CITY OF WACONIA PLANNING COMMISSION AGENDA

- A. PUBLIC HEARING: Sudheimer Retail Addition PRELIMINARY AND FINAL PLAT APPLICATION submitted by KTJ 290, LLC, for the properties located at 10590 and 10594 10th Street West. Pages 6-16

- B. SITE PLAN and DESIGN REVIEW: Request submitted by KTJ 290, LLC, for a proposed freestanding retail building, multi-tenant building and other site improvements - Lot 1, Block 1, Sudheimer Retail Addition. Pages 17-31

The City of Waconia staff have reviewed the proposed Preliminary Plat application for the Sudheimer Retail Addition commercial development drafted by Kimley-Horn Associates, Inc. dated August 31st, 2016 and provide the following review and comments:

SHEET NUMBER C-3.0

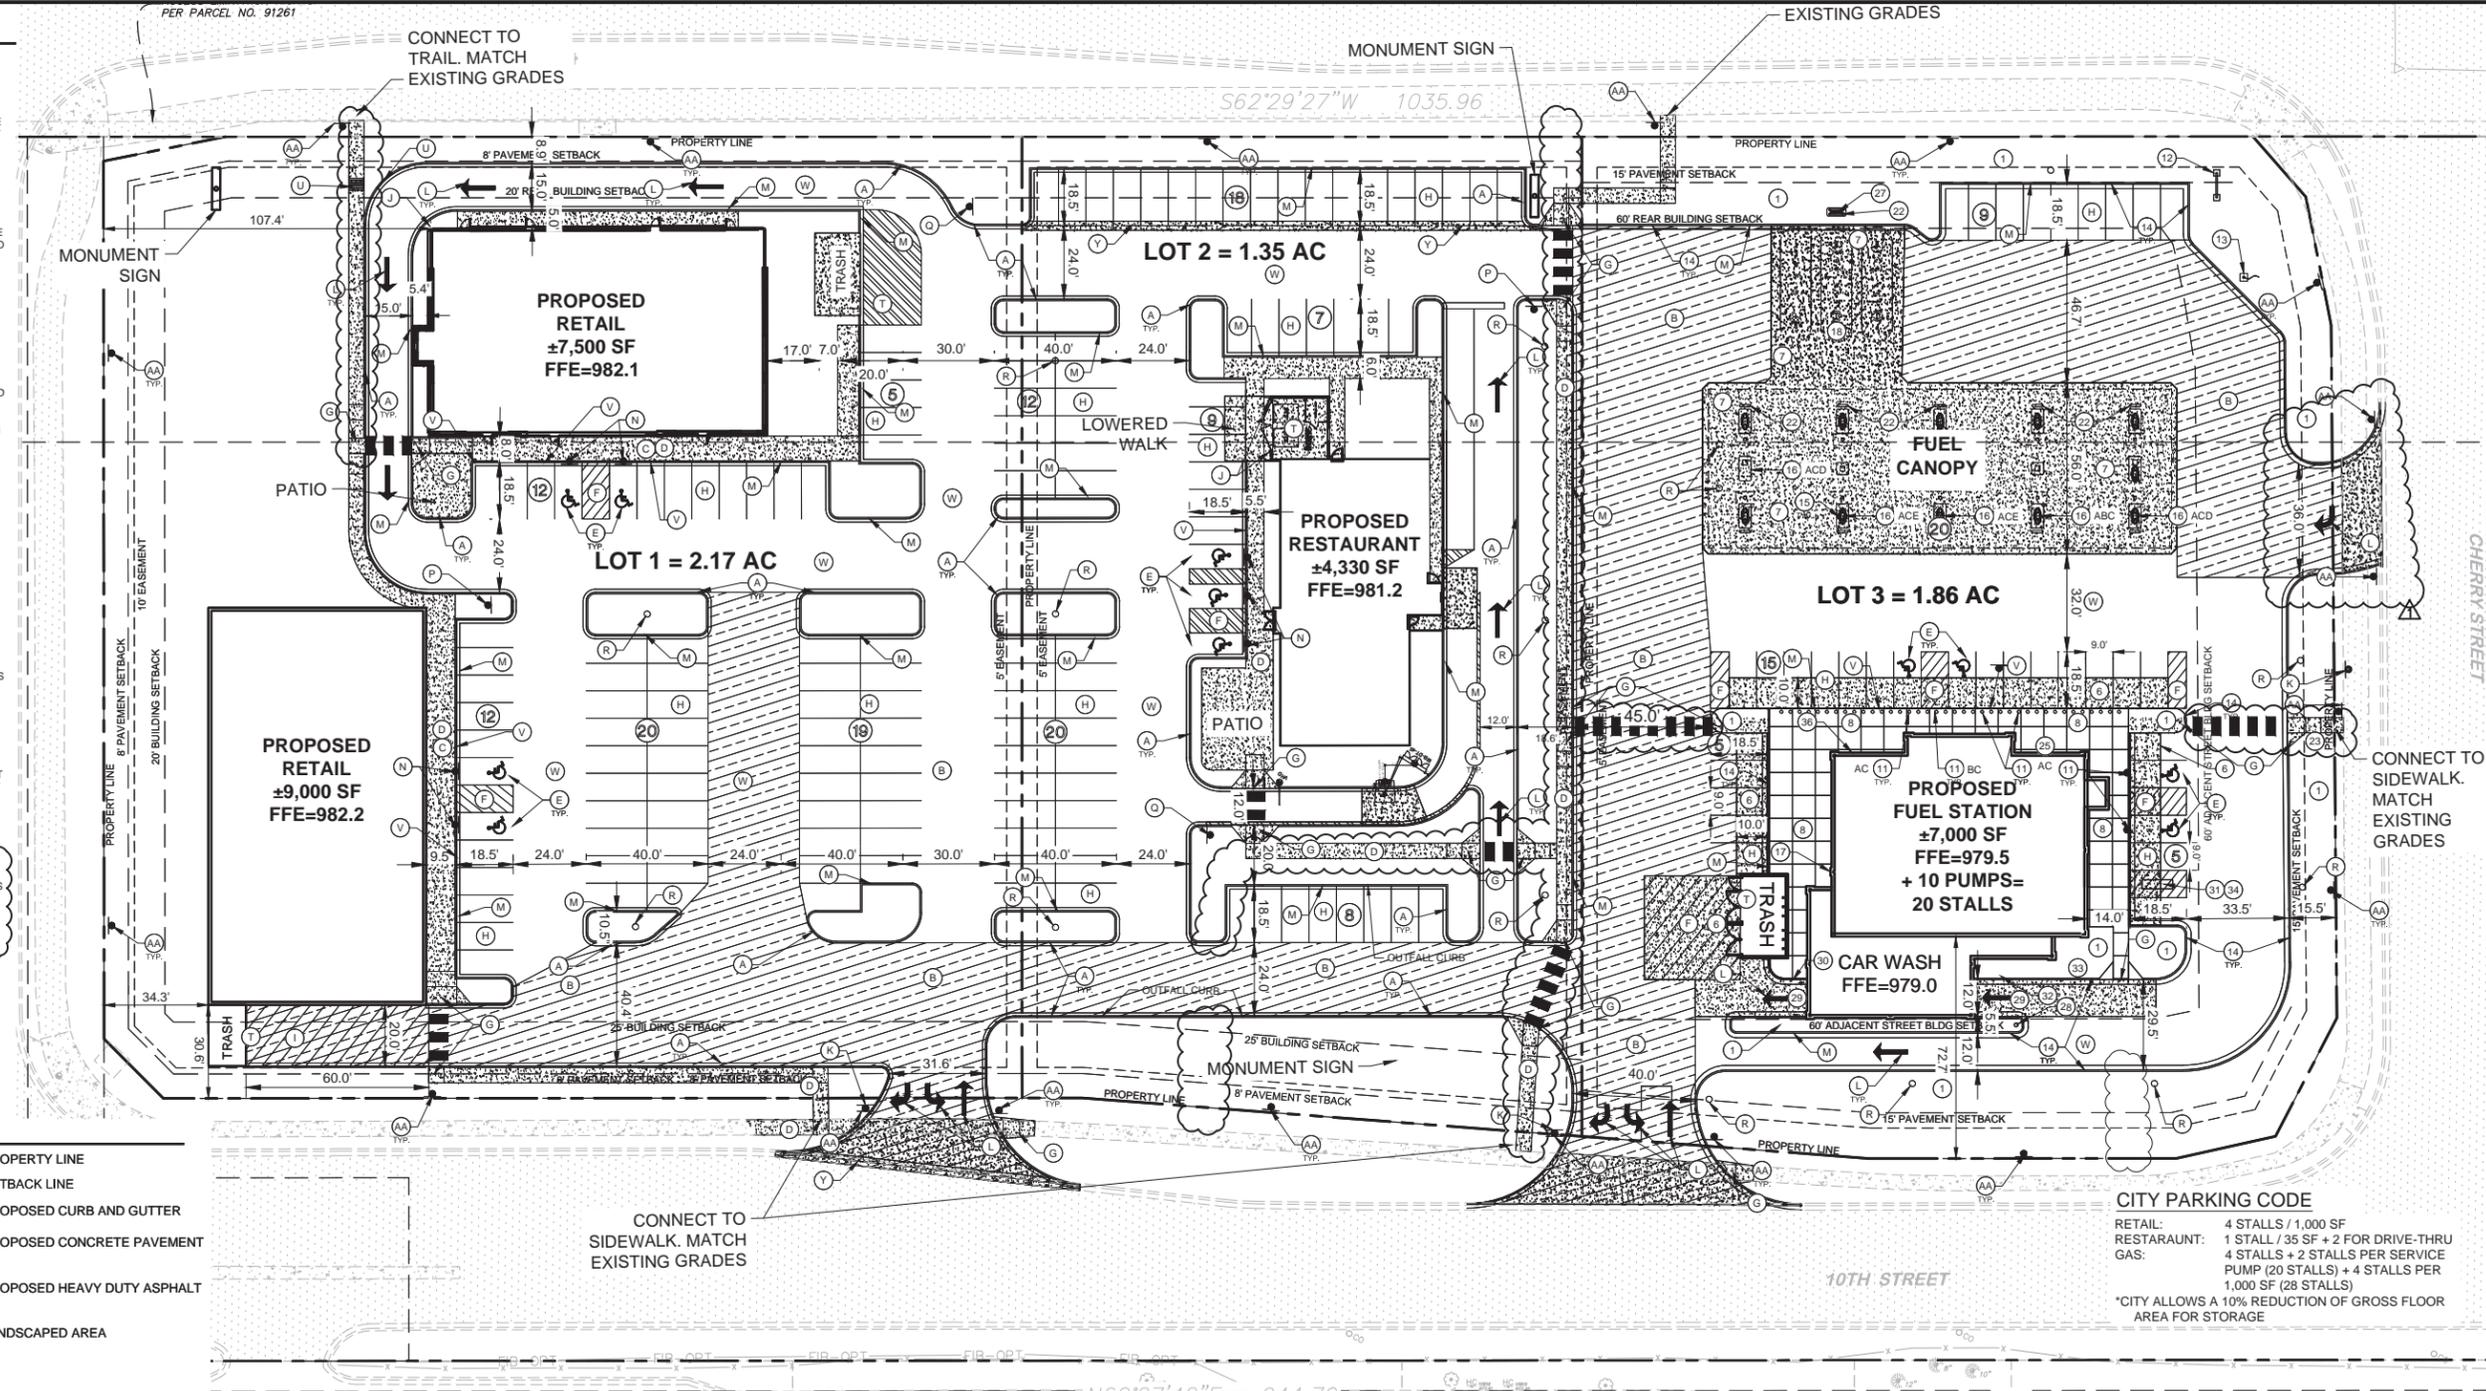
Staff is requesting the plat be revised to include a separate outlot at the stormwater pump station. This is the triangular piece of the 10th Street right-of-way located to the south of Outlot A.

- Provide a copy of the Carver County Water Management Organization permit, the NPDES permit, and any other approved permits.
- Provide a copy of the updated plats showing the separate triangular parcel (south of Outlot A) where the stormwater reuse pump is located.

- The Stormwater Pollution Prevention Plan (SWPPP) needs to be submitted.
- The 36' wide right-in only entrance of Cherry Street will not function as designed with only signing and striping to restrict other turning movements. This entrance is recommended to be reduced to be 16'–18' wide. Either the planned truck access route needs to be modified or this entrance needs to be modified to include a concrete surmountable apron.

- Cleanouts have been added to storm sewer bends as requested. Consideration should also be given to adding cleanouts at the two proposed tee locations.

7. Compliance with applicable items contained in Chapter 1000 of the City of Waconia Subdivision Ordinance.
8. The plat shall be revised to include a separate outlot at the stormwater pump station. This is the triangular piece of the 10th Street right-of-way located to the south of Outlot A.

SHEET NUMBER C-3.0

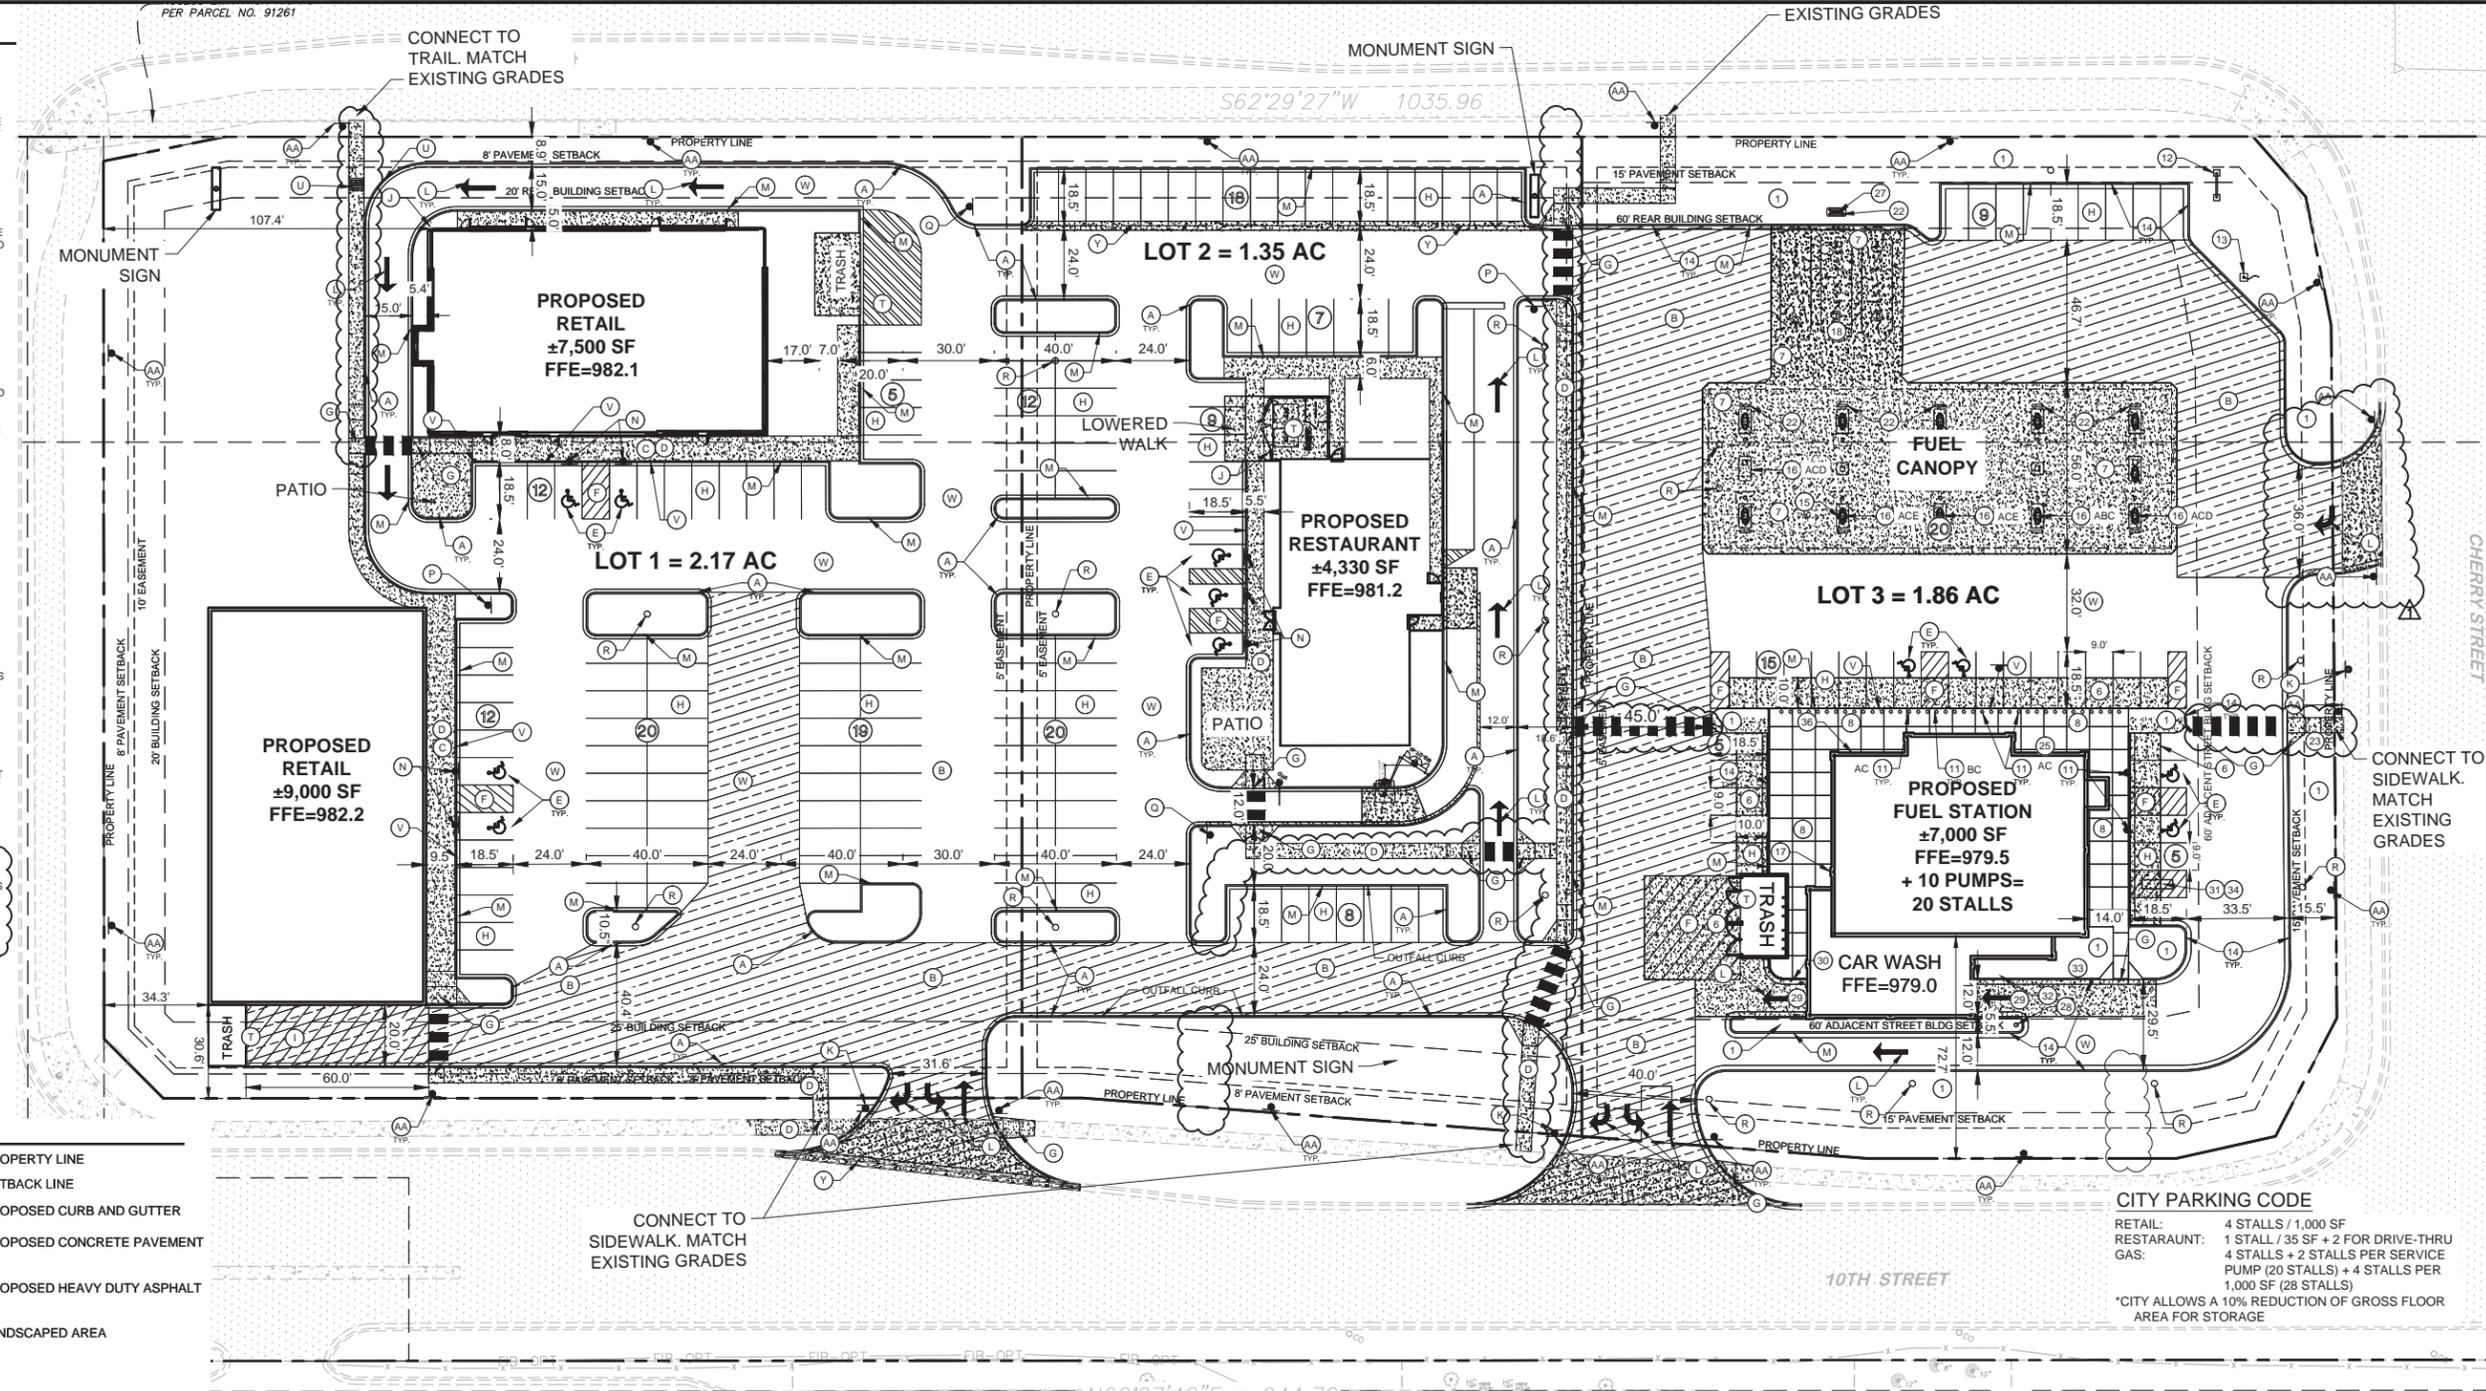
The structure setbacks, building height, and hardcover surface requirements stated above have been satisfied based on a review of the Site Plan – C-3.0 dated 09/26/16 and the exterior elevations provided for both buildings.

The applicant should clarify the proposed signage for the site. There is a discrepancy in the plan set with some sheets indicating a monument sign at the corner of Hwy. 5 and CSAH 10 and an additional pylon sign along Hwy. 5. Pylon signs are prohibited and only one monument sign is allowed per premises of record in the B-1, Highway Business District and therefore will not be permitted as proposed. A recommendation of approval regarding this application does not approve the placement of a pylon sign on the property.

The placement of the required bike rack shall be clarified as the keynotes for the site plan indicate a bicycle rack, but one has not been provided on site.

7. The plans shall be revised to include bicycle parking consistent with the Pedestrian and Bicycle Access Design Standard.
8. The additional plantings required for frontage along Hwy. 5 shall be indicated on the landscape plan. The additional plantings total 17 trees for the entire site. The plantings will require a minimum 3 inch deciduous or 8 ft. coniferous tree. This is in addition to the 41 trees required per landscape requirements.

13. The applicant shall provide a bicycle rack on site.
14. The applicant shall revise the landscape plan to include screening consistent with the Parking Lot Landscaping Design Standard.
